P 523945

**ON-SITE SEWAGE DISPOSAL SYSTEM  
HOWARD COUNTY HEALTH DEPARTMENT  
BUREAU OF ENVIRONMENTAL HEALTH**

SUBDIVISION: Curan Property LOT NUMBER: 3

ADDRESS: 4971 Green Bridge Road PROPERTY OWNER: Wayne Ballantine

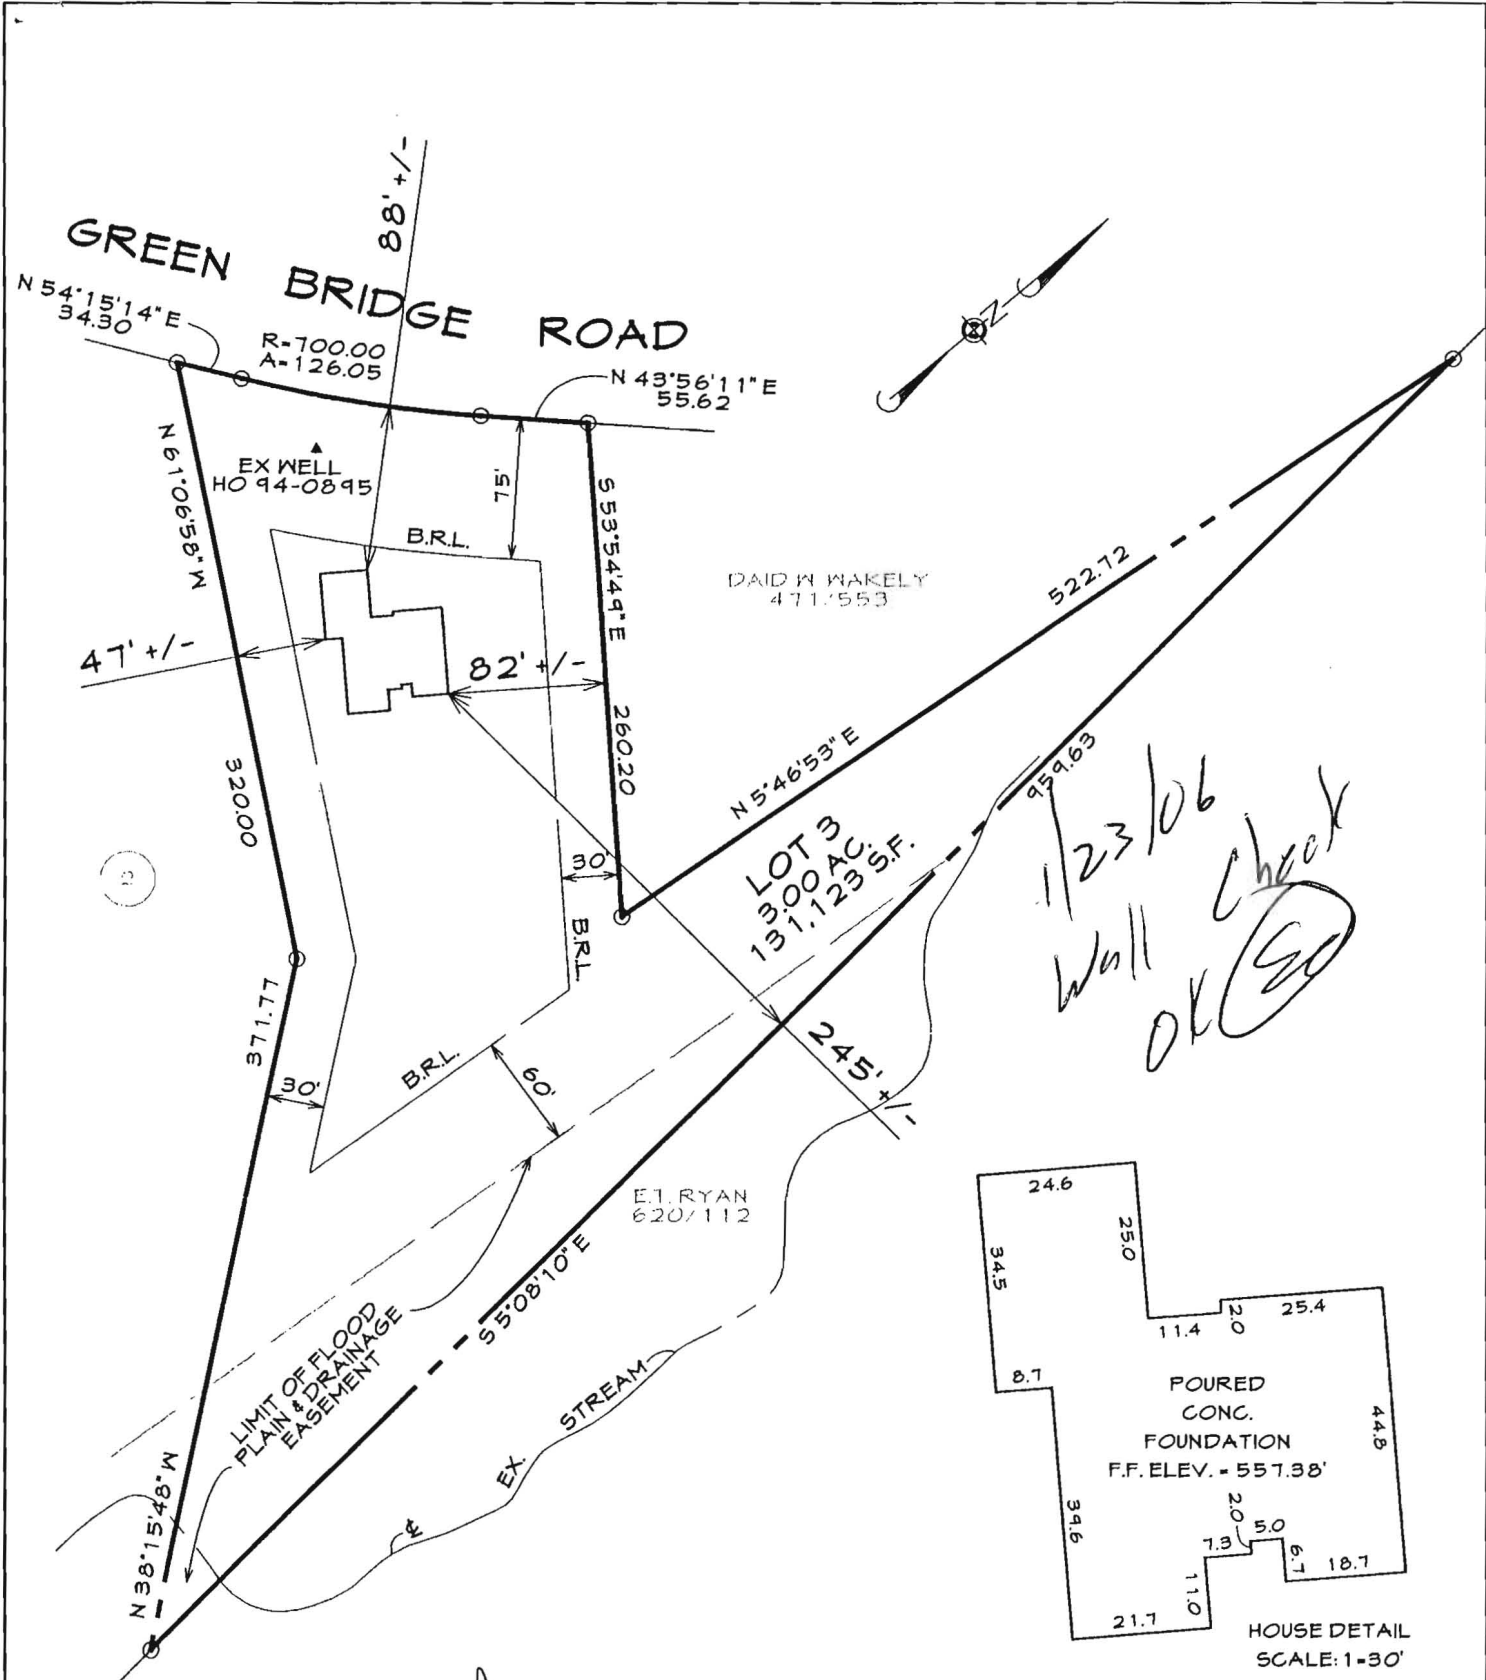
INSTALLATION 2/2/06 No layout done. Need house connection. Trenches should have been designed to be longer - area wasted. O.K. to backfill. (BB)
